Access Compliance Report

Public Rights-of-Way

Intersection ID: 21461	Main Street: FOREST_POINT_BV	Cross Street: W_ARROWWOOD_RD	Location: N
ADA ID: DDC85C335B4F	Ramp Type: PerpDiag	Initial Pass/Fail: Fail	Overall Compliance: No
			Severity Score: 46.25

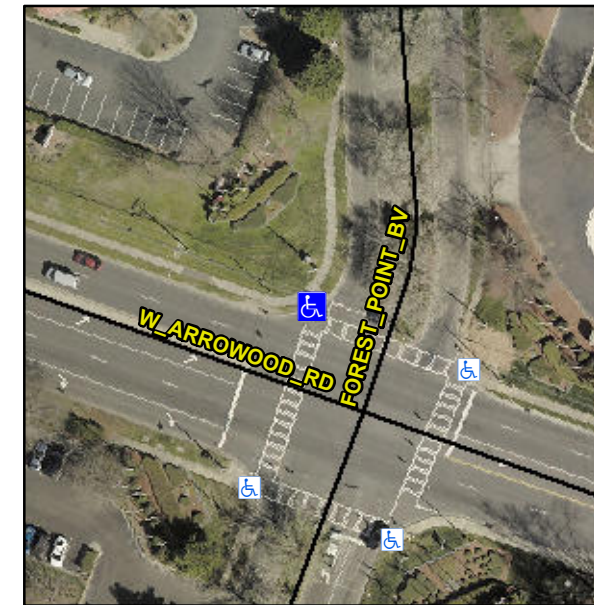
Not Found, R304.5.1, R304.2.2, R304.5.3

Compliance	Description	Data	Compliance	Description	Data
N/A	Ramp Length (in)	123.0	No	Ramp Slope (%)	9.2
No	Ramp Width (in)	39.0	No	Ramp XSlope (%)	11.0
N/A	Flare Type LT	N/A	N/A	Flare Type RT	N/A
N/A	Flare Slope LT (%)	N/A	N/A	Flare Slope RT (%)	N/A
N/A	Flare Traversable LT?	N/A	N/A	Flare Traversable RT?	N/A
N/A	Landing Length (in)	N/A	N/A	DWS Provided?	N/A
N/A	Landing Width (in)	N/A	N/A	DWS Contrast?	N/A
N/A	Landing Slope (%)	N/A	N/A	DWS Length (in)	N/A
N/A	Landing X Slope (%)	N/A	N/A	DWS Full Width?	N/A
N/A	Landing Curb? (Y/N)	N/A	N/A	DWS Offset (in)	N/A
N/A	Shared Landing?	N/A			
N/A	Gutter Ponding?	N/A	N/A	Gutter Slope (%)	N/A
N/A	Gutter Lip Ht (in)	N/A	N/A	Gutter X Slope (%)	N/A
N/A	Painted X Walk1?	Yes	N/A	Painted X Walk2?	Yes
	X Walk 1 Direction	To SW		X Walk 2 Direction	To SE
N/A	X Walk 1 Width (in)	111.0	N/A	X Walk 2 Width (in)	85.0
	X Walk 1 Slope (%)	3.5		X Walk 2 Slope (%)	4.4
	X Walk 1 X Slope (%)	1.7		X Walk 2 X Slope (%)	2.6

Remove & Replace Curb Ramp With Two New Directional Ramps or Equivalent. Restripe Crosswalk.
